Kidman Resources and SQM Earl Grey Lithium Project Section 43A Request

The purpose of this document is to request to change the Proposal under s 43A of the EP Act. This document has been prepared in accordance with the requirements identified in Section 3.8 of the *Environmental Impact Assessment (Part IV Divisions 1 and 2) Procedures Manual 2016* (EPA 2016). Specifically, this report has been structured to:

1. Description of change

Figure 1: Proposed Site Layout

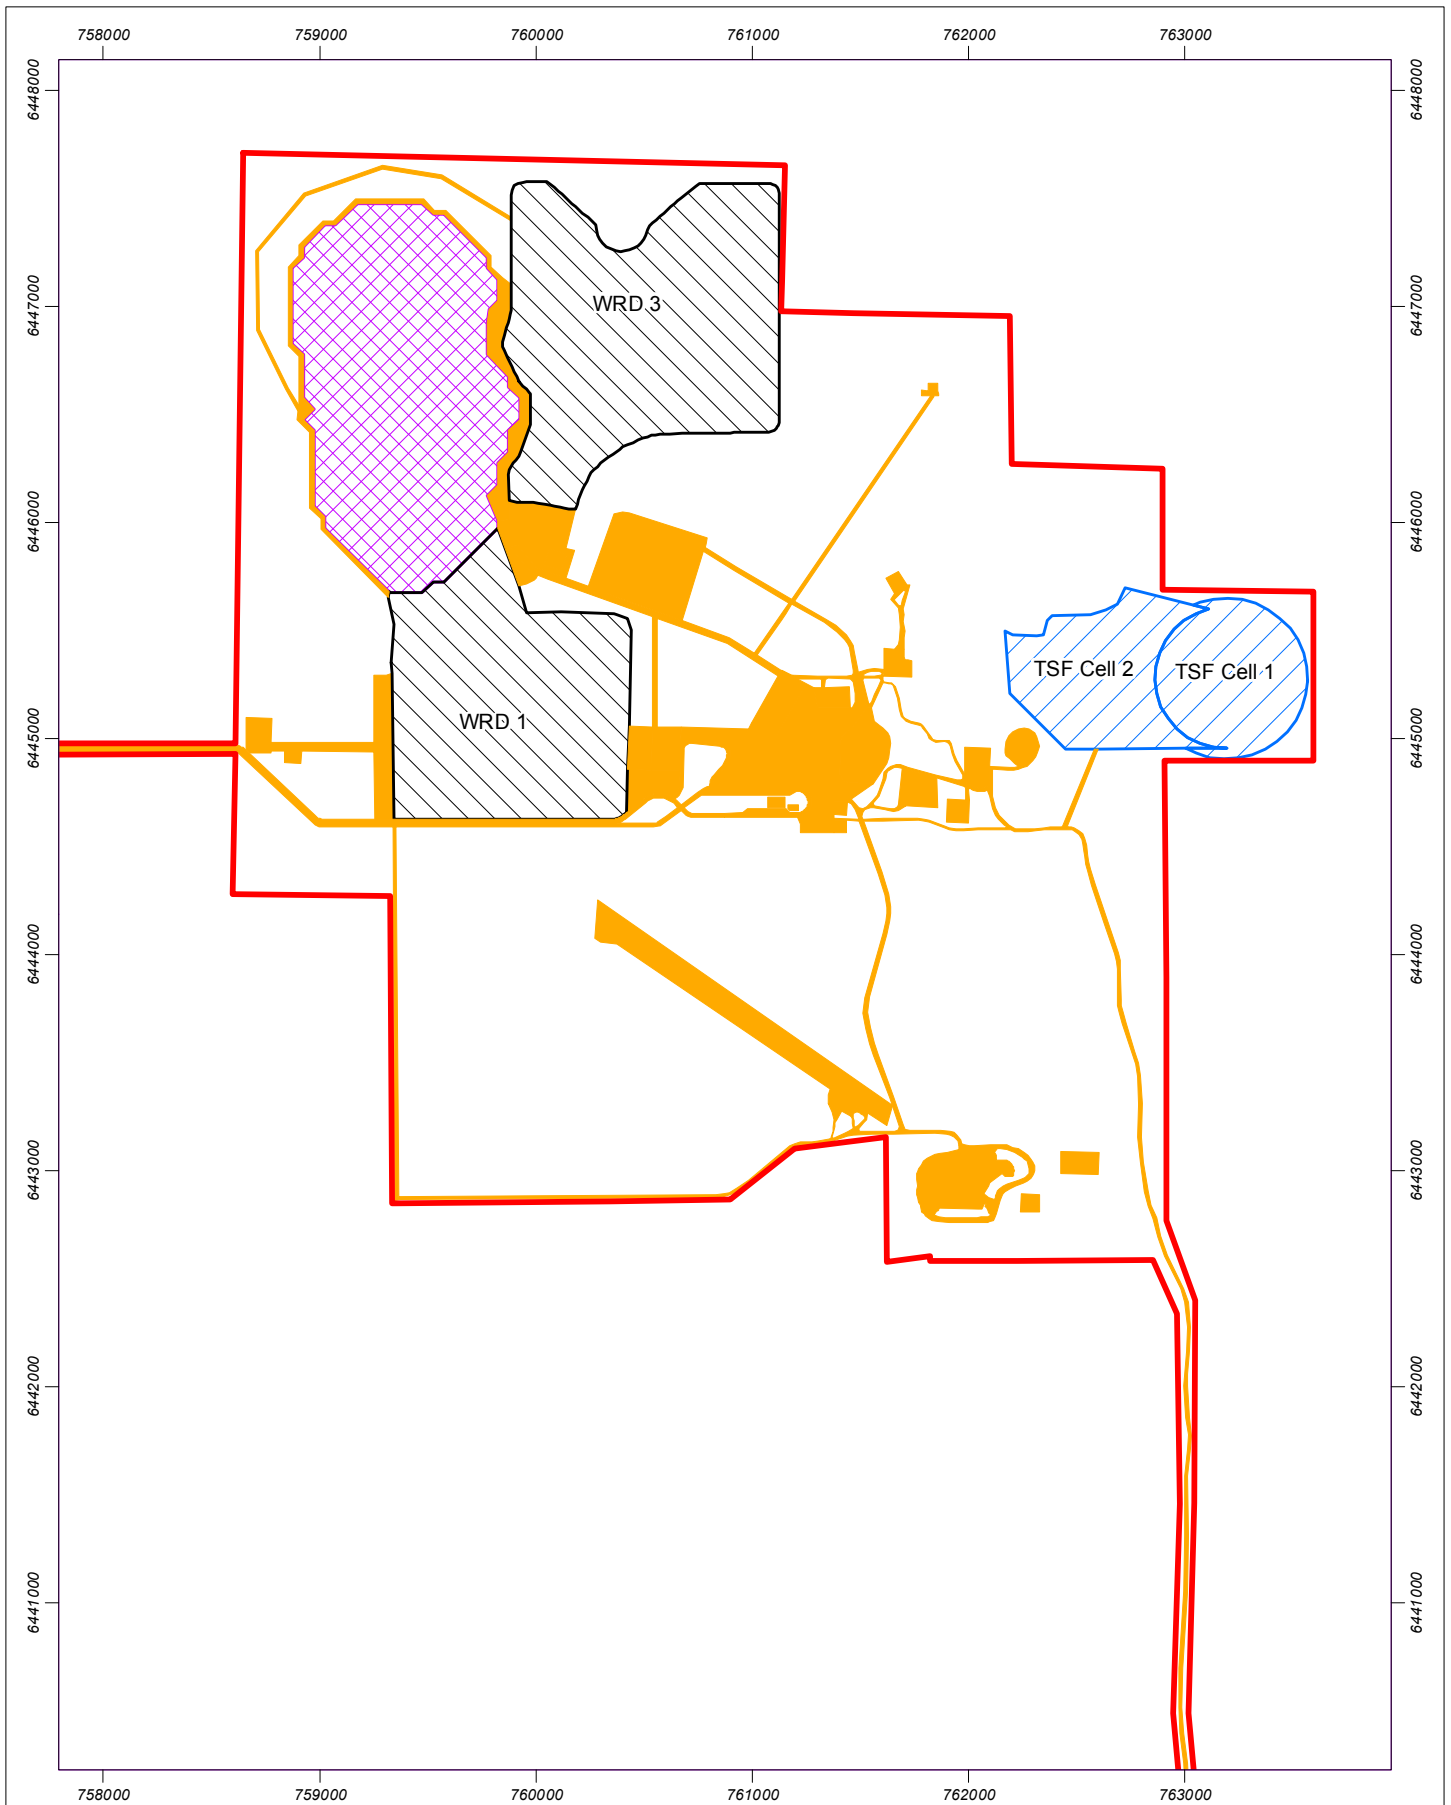
1. Modification to the design of a Waste Rock Dump (WRD) to avoid an active Mallee Fowl nest.
2. Increase to the tailings storage capacity requirements, which increases the extent of Tailings Storage Facility (TSF) (also resulting in a decrease in the extent of the WRD).
3. Incorporation of existing road network that will be used as part of the Proposal into the description of the Proposal.

The revised proposed site layout and development envelope is shown in Figure 1. The differences to the indicative footprint set out in the referral as a result of the proposed change are shown in Figure 2.

Figure 2: Comparison of proposed change to footprint with referred footprint

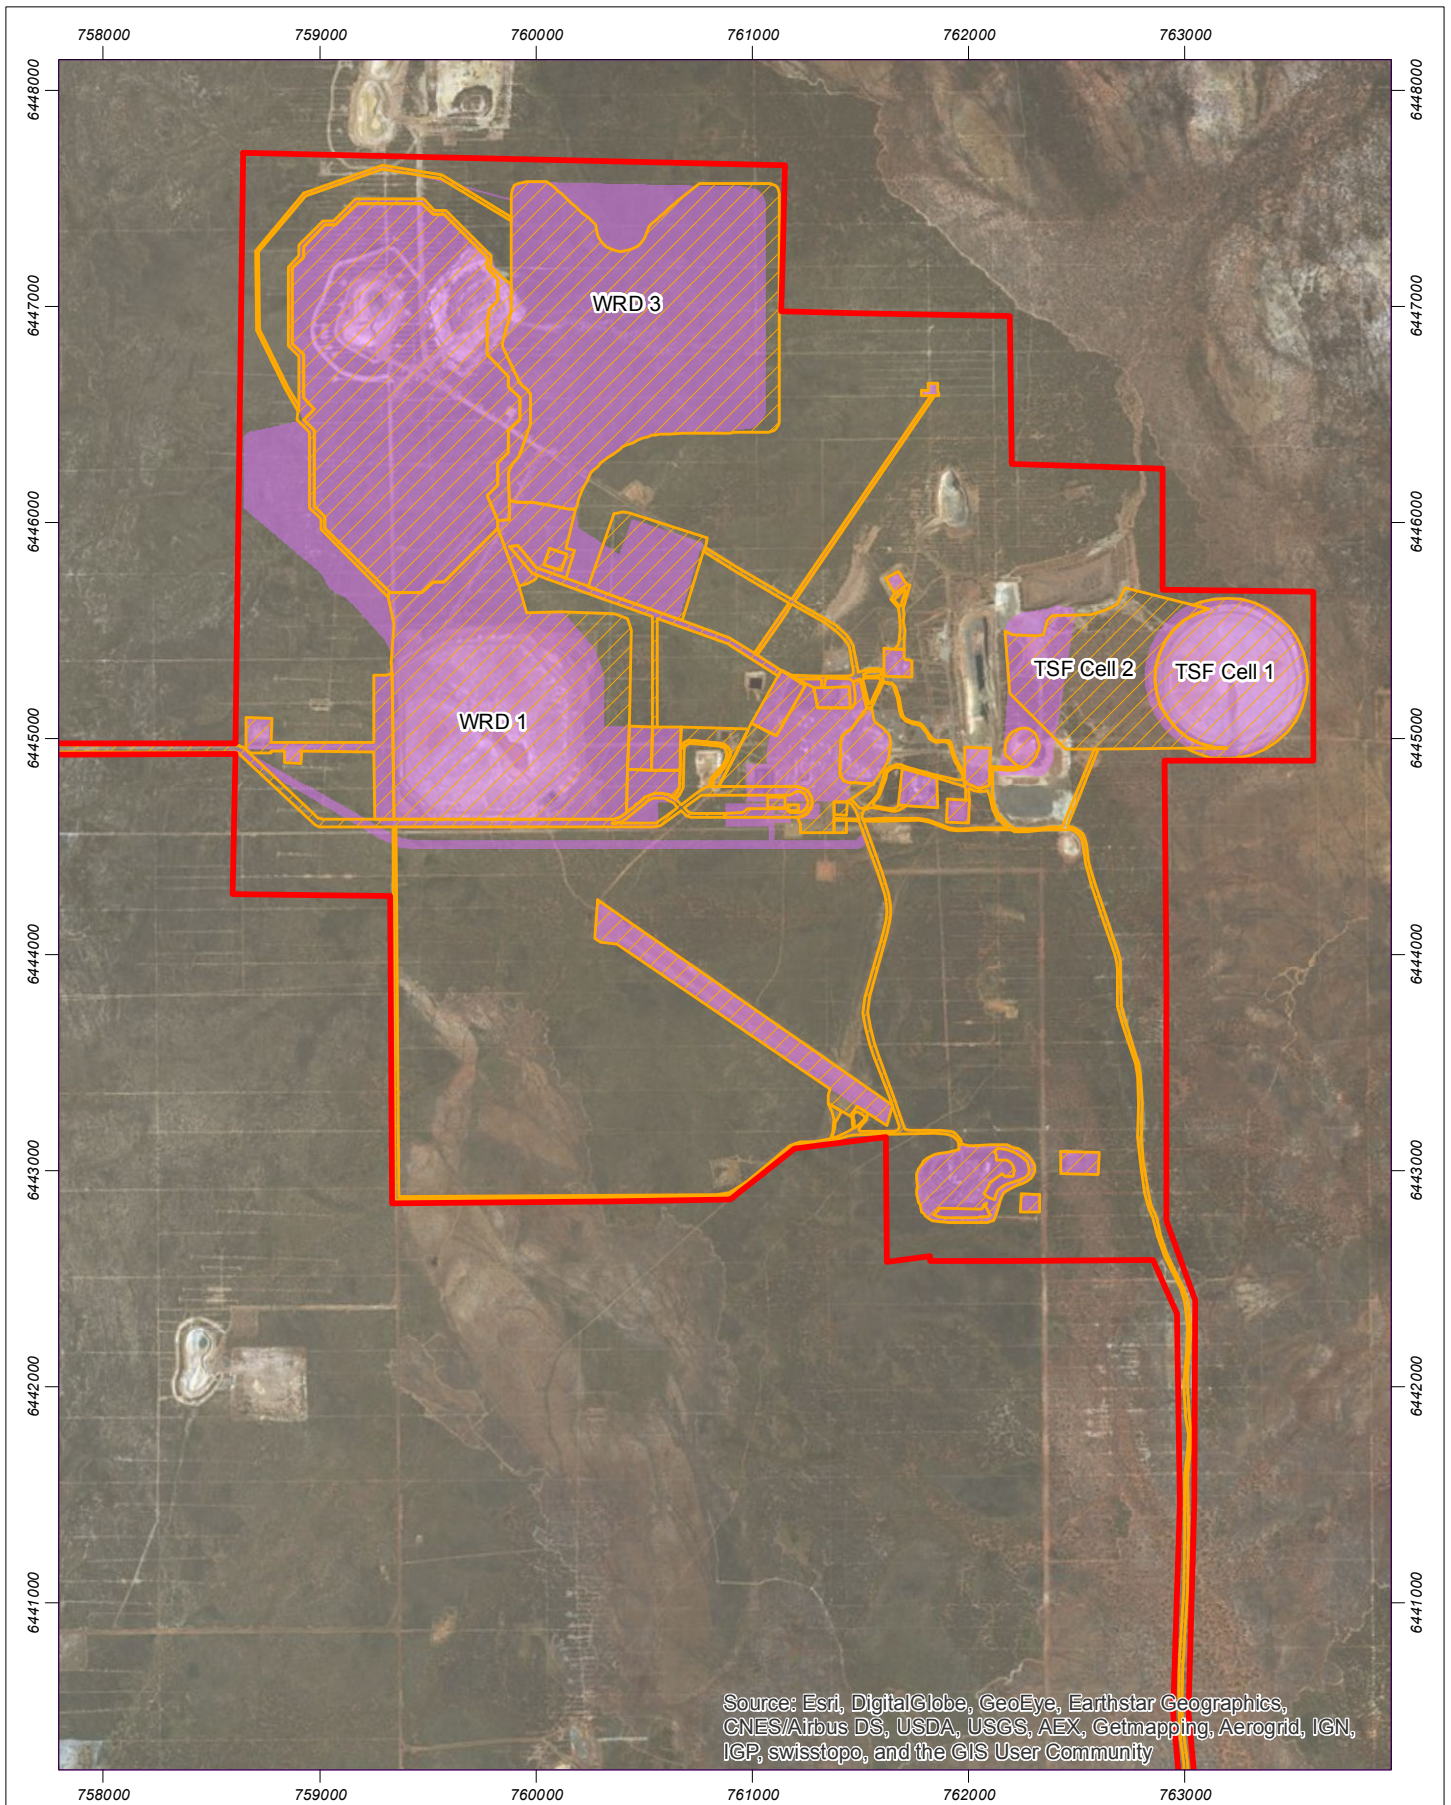
The overall outcome of the proposed change is an increase in the footprint of Proposal from 610 ha to 705 ha, which will also result in an increase in the extent of native vegetation clearing from 365 ha to 392 ha.

The modification of the WRD in the north of the Development Envelope has been undertaken to avoid an active Mallee Fowl nest. This change has been undertaken for the sole purpose of minimising the impact of the Proposal on a species of conservation significant fauna.

The increase in the storage capacity requirements of the tailings storage facility increases the extent of the footprint required for the TSF. While less material will be transported to the WRD, as the design has been modified to avoid a Mallee Fowl nest the design is less efficient and therefore the footprint of the WRD has not been able to be substantially reduced.
